## **Additional Information for the Condition (1) of LBLOCA SER**

<LBLOCA SER p.45>

For example: Test 34006 (Flooding rate of 1.5 cm/sec)

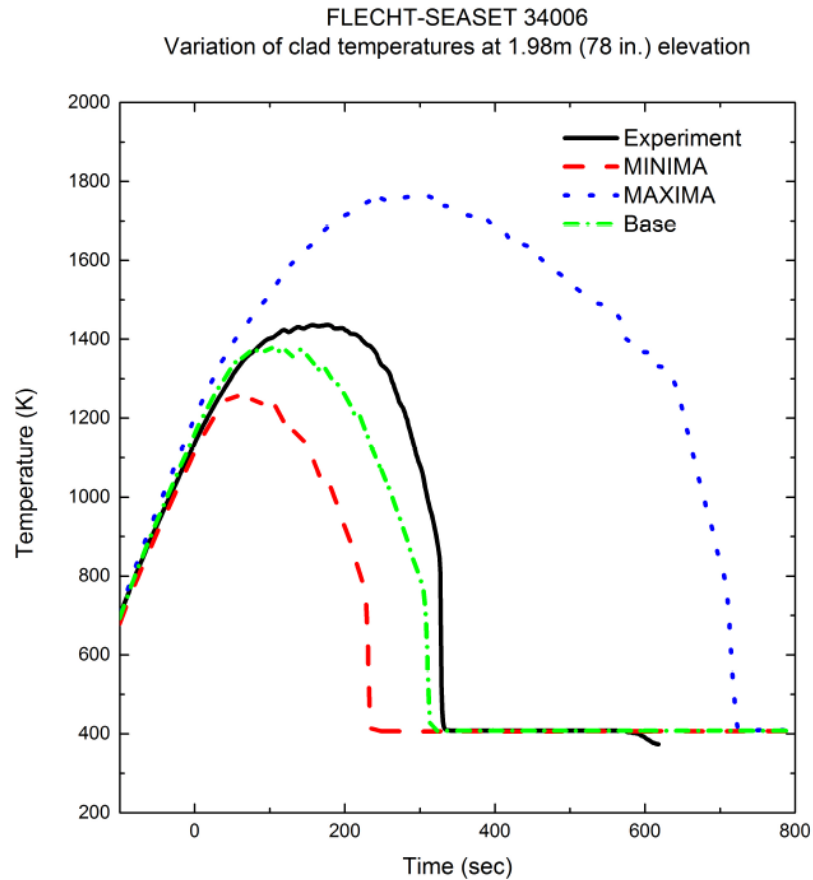
The NRC staff could not confirm the applicant's response during the January 2016 Audit Meeting. Therefore, the NRC staff imposes Condition (1) on the use of CAREM:

*Should changes to the APR1400 configuration, evaluation model, or design input result in large break LOCA flooding rates lower than 10 cm/sec, the CAREM analyses shall require additional justification and NRC approval.*

The phrase of condition (1) need to be deleted or modified because of the following reasons:

CAREM follows best-estimate with uncertainty propagation approach.

- For each code assessment against test data, the calculated cladding temperature of the base case calculation does not need to cover the maximum measured data based on the best-estimate approach.
- The purpose of base case calculation is to confirm the general thermal-hydraulic behaviors and the code predictability (or code accuracy) by evaluating PCT difference between calculated and measured values.
- The code accuracy obtained from base case calculation is used to estimate the degree of uncertainties.
- On the other hand, the 3<sup>rd</sup> highest PCT of SRS calculation is checked whether the selected uncertainty parameters and their ranges can cover the maximum measured PCT or not in the Experimental Data Covering (EDC) step of CAREM.

- Based on the best-estimate with uncertainty propagation approach, if the 3<sup>rd</sup> PCT can cover the maximum measured PCT, it concluded that selected uncertainty parameters and their ranges are appropriate.
- The other assessment results for low flooding rate tests show that calculation results by best-estimate with uncertainty propagation approach can cover the maximum measured PCTs as shown in below:
